HISTORIC AND DESIGN REVIEW COMMISSION

HDRC CASE NO: 2018-283

COMMON NAME: 714 SHERMAN

TYPE OF WORK: Construction of 300 sq ft primary structure

714 SHERMAN
SITE PLAN

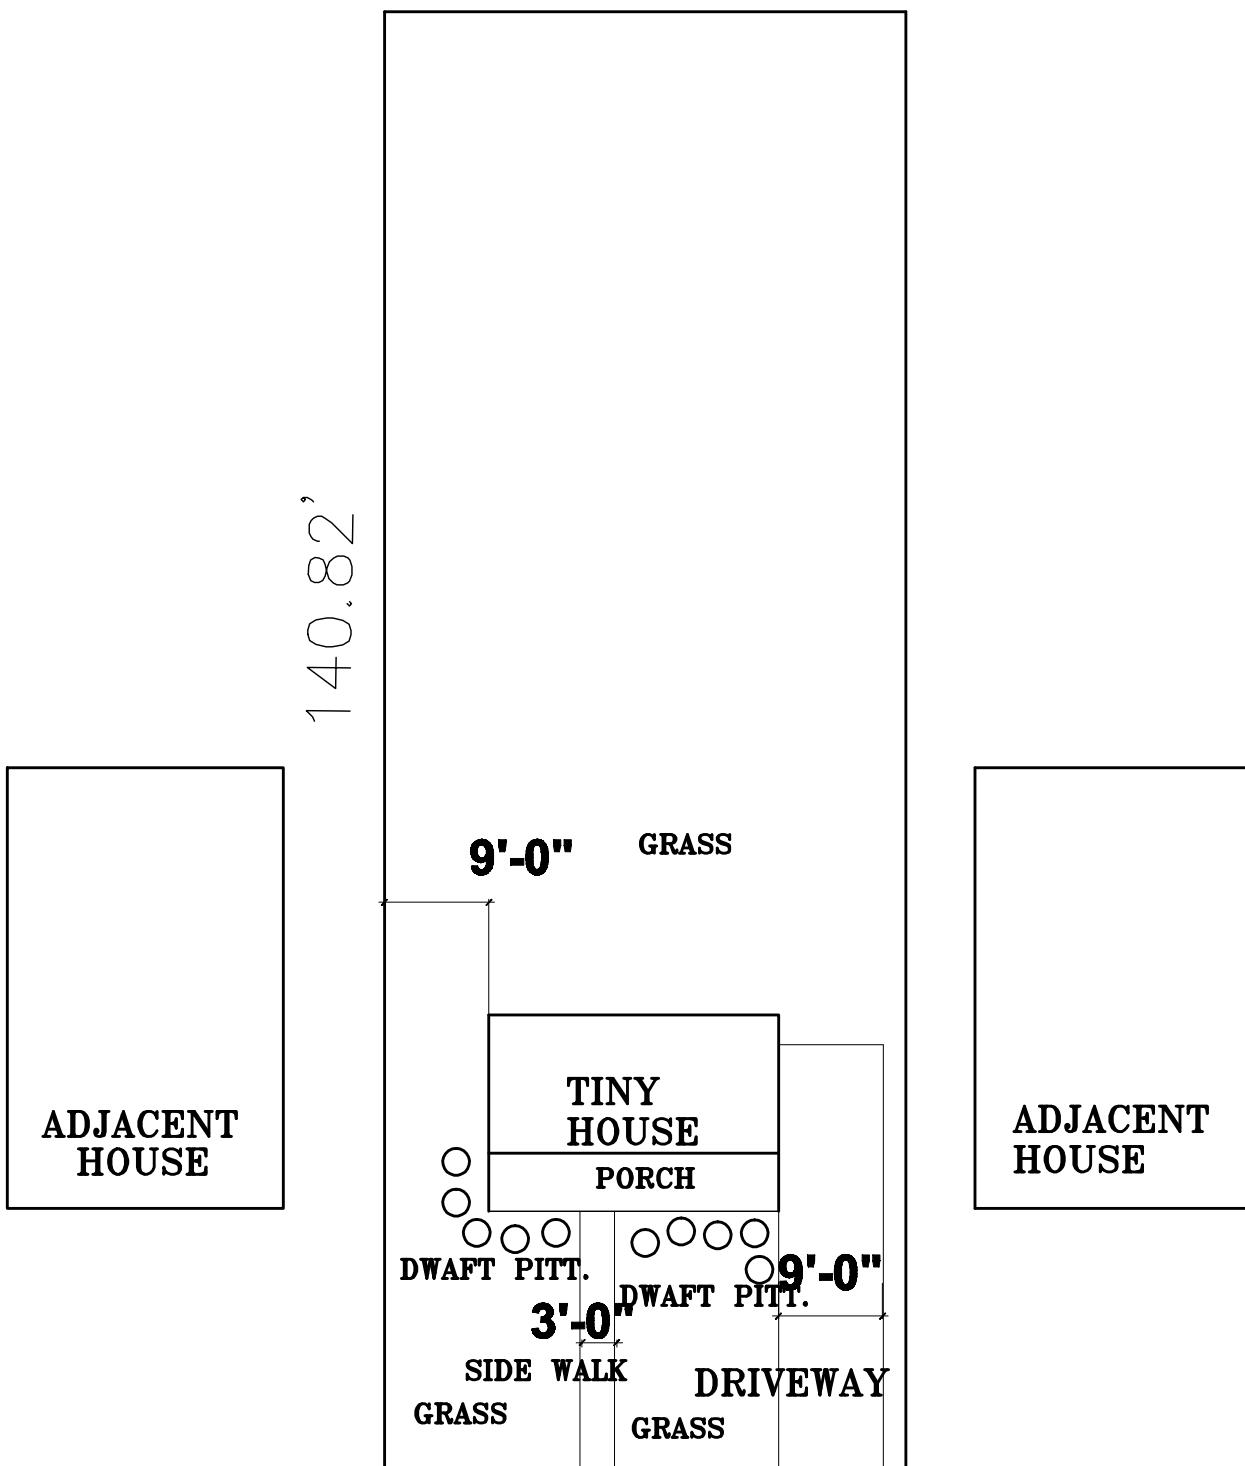
- i. The setback and orientation condition should be similar to those found in the district: side-flanking driveway to off-centered primary structure rather than the proposed centered driveway.

- iv. A measured and developed site plan with landscape details should be submitted for final approval.
- c. SETBACKS & ORIENTATION – According to the Guidelines for New Construction, the front facades of new buildings are to align with front facades of adjacent buildings where a consistent setback has been established along the street frontage. Additionally, the orientation of new construction should be consistent with the historic examples found on the block. The applicant has provided a setback that is consistent with the neighboring properties on each side of the lot; however, the applicant has proposed an overall orientation that is inconsistent with the Guidelines. This block of Sherman features two, historic shotgun structures. Staff finds that an appropriate orientation for the structure that includes the narrow façade addressing the street, incorporating a front porch, consistent with the neighboring shotgun structures.

1. PORCH – The applicant has proposed a porch that spans the entire width of the structure's widest façade. The adjacent shotgun structures feature the narrowest façade fronting the street with porches spanning the width of the street facing façade. Their porches inches shed porch roofs that commence at the top plate of the street facing wall plane. Staff finds that a front porch design that is comparable to those found on the adjacent shotgun houses should be incorporated into the design.
- m. SITE ELEMENTS – The applicant has submitted a site plan that includes a 9 ft wide driveway flanking the right side of the structure, a 3 ft wide walkway to the porch, and a predominantly grass lawn with plantings surrounding the porch. Staff finds the site elements proposed are consistent with the Guidelines.

Staff does not recommend approval of the new construction based on findings c, d, e, and l. Staff recommends the applicant modify the proposed design to be complementary of the adjacent shotgun structures.

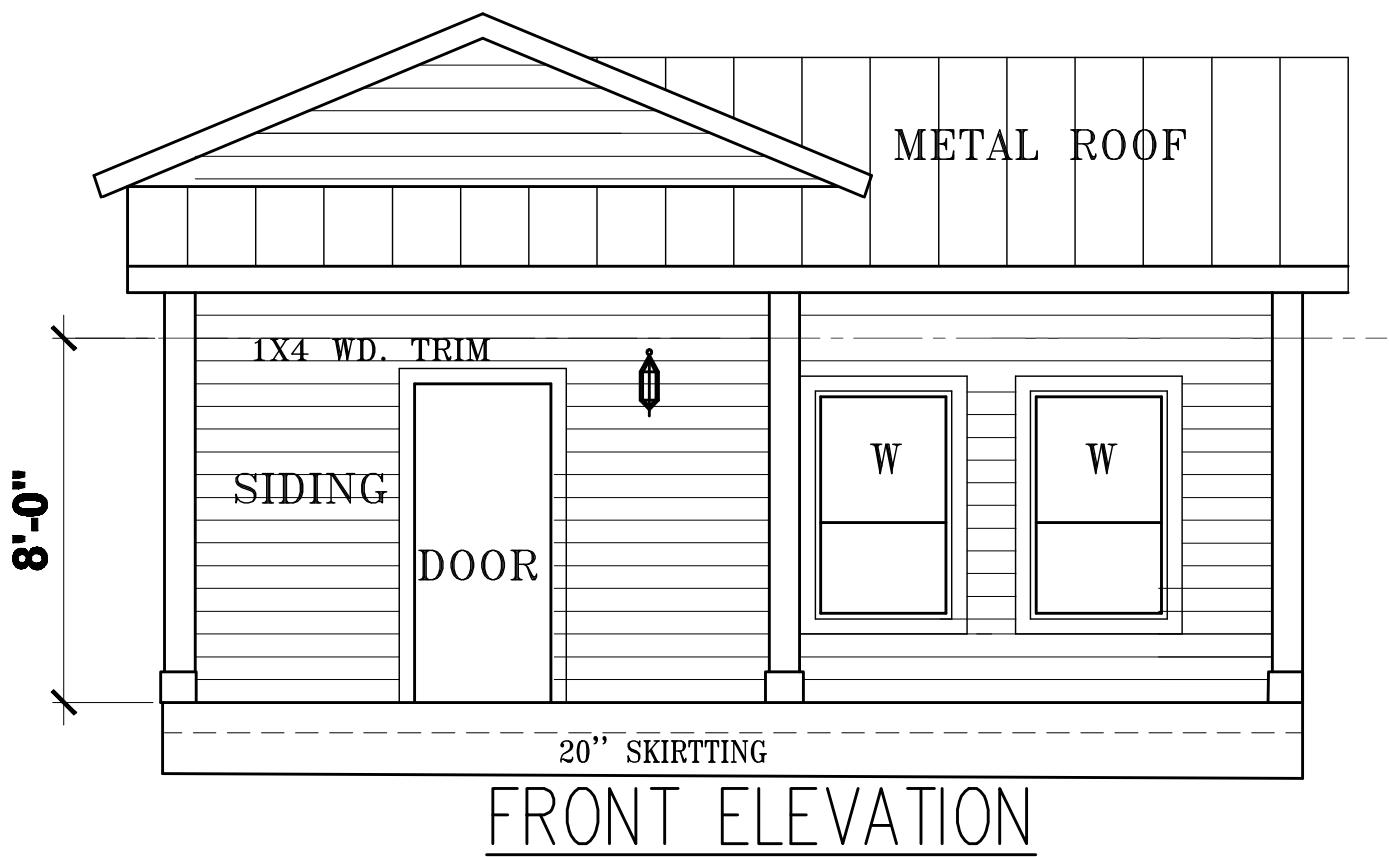
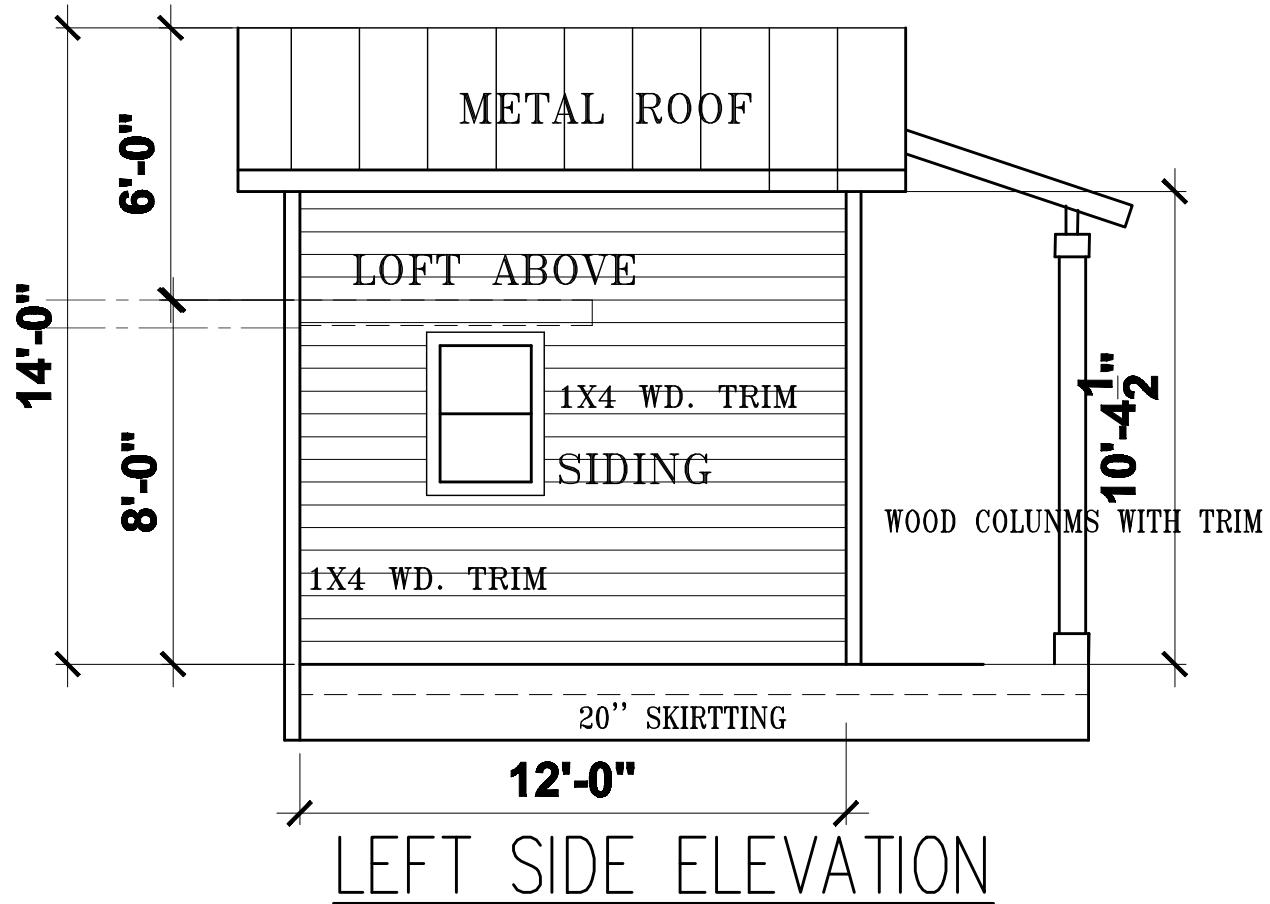
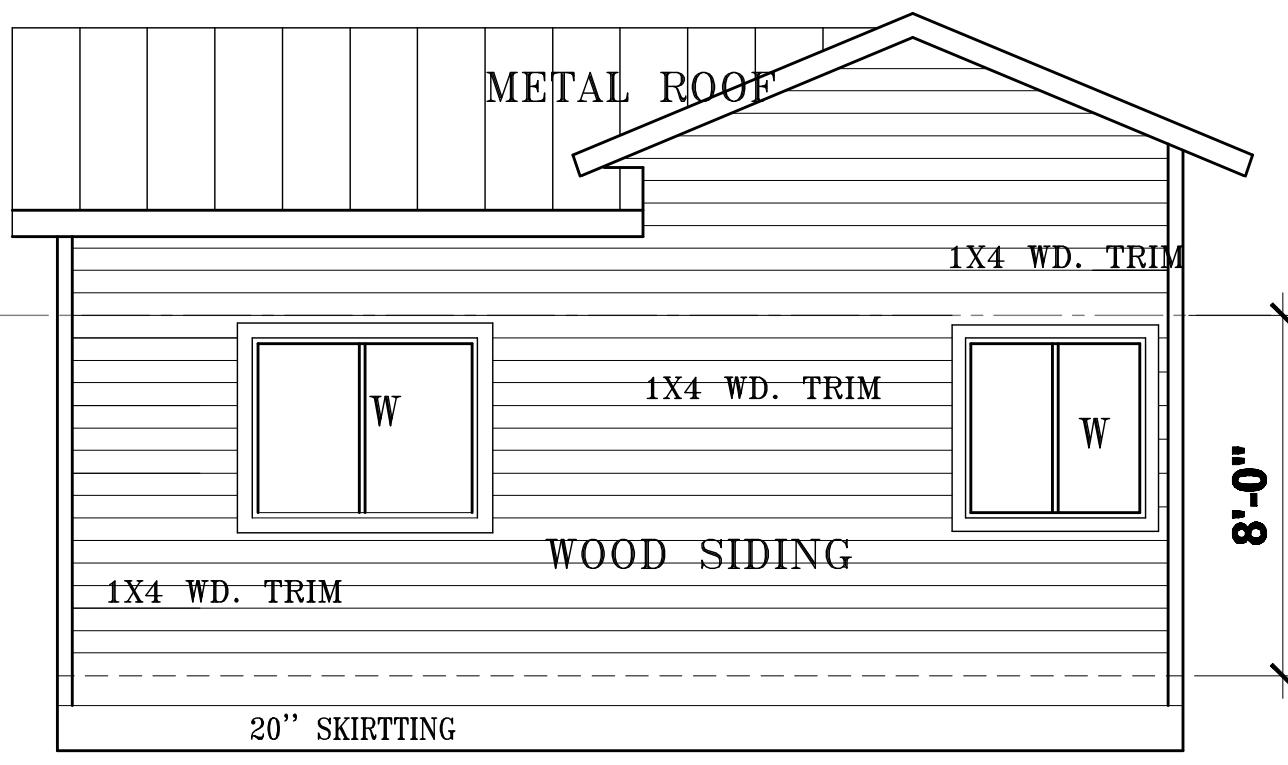
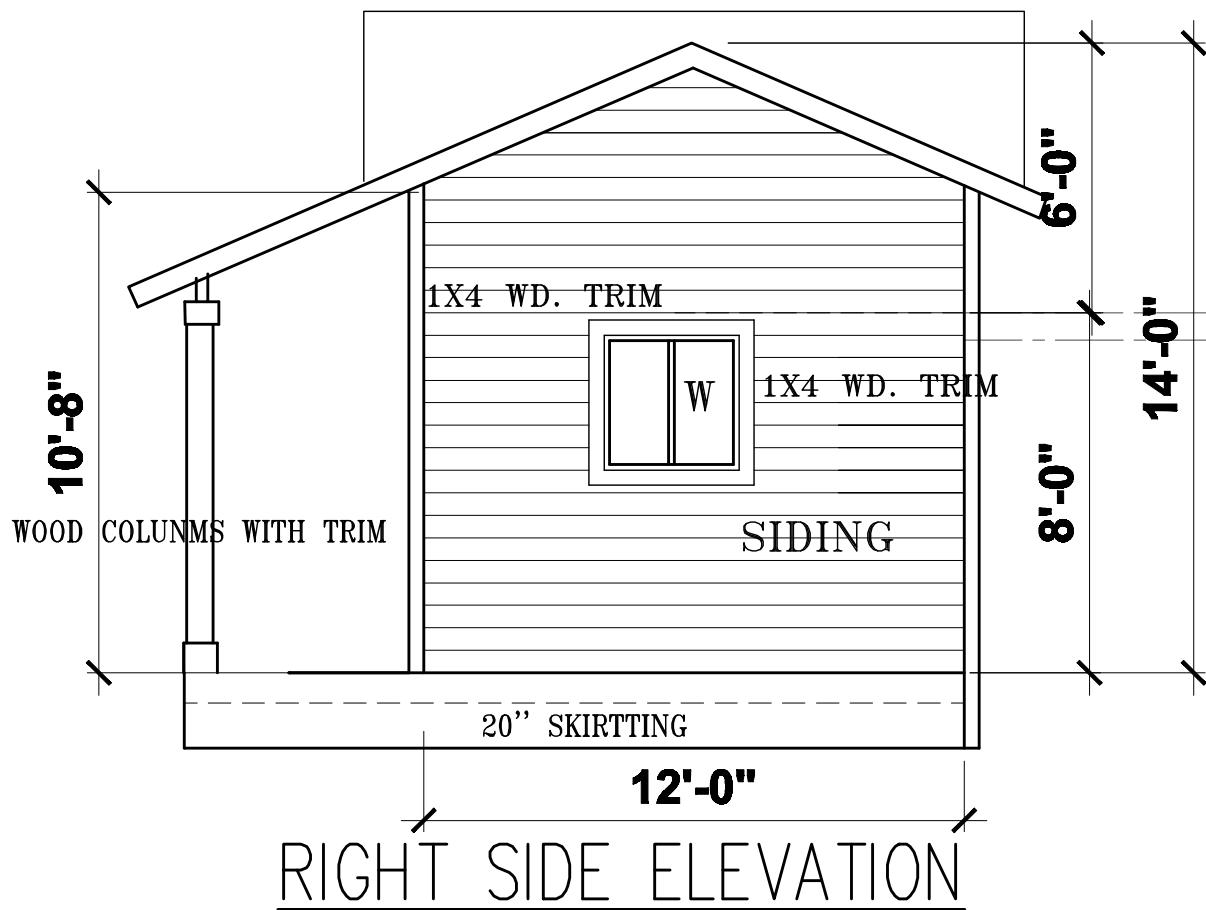
- ii. The roof form should be similar to those found in the district: hipped and gabled roofs rather than the proposed shed roof.
 - iii. Fenestration details should be similar to those found in the district: wood sashed windows.

- e. SCALE & MASS – Per the Guidelines for New Construction 2.A.i., a height and massing similar to historic structures in the vicinity of the proposed new construction should be used. In residential districts, the height and scale of new construction should not exceed that of the majority of historic buildings by more than one-story. This block of Sherman features six (6) one-story historic structures on the south side of the block. Staff finds the general scale and mass of the structure to be consistent with the Guidelines; however, staff finds that the smaller mass of the structure should be oriented toward the street to be comparable to the adjacent shotgun structures.

- g. ROOF FORM – The applicant has proposed a roof form featuring a primary gabled roof with a crossed gable and a shed roof over the porch. Historic structures within the district feature hipped or gabled roofs. Per findings c, d and e, staff finds that the proposed new construction should be comparable in scale and design to the neighboring shotgun structures. This would result in a front facing gabled roof with a shed porch roof.

- h. WINDOW & DOOR OPENINGS – Per the Guidelines for New Construction 2.C.i., window and door openings with similar proportions of wall to window space as typical with nearby historic facades should be incorporated into new construction. The proposed design features a total of three (3) one-over-one wood windows on the front and right side, and three (3) sliding windows on the rear and left side of the structure. Staff finds the one-over-one and sliding windows appropriate.
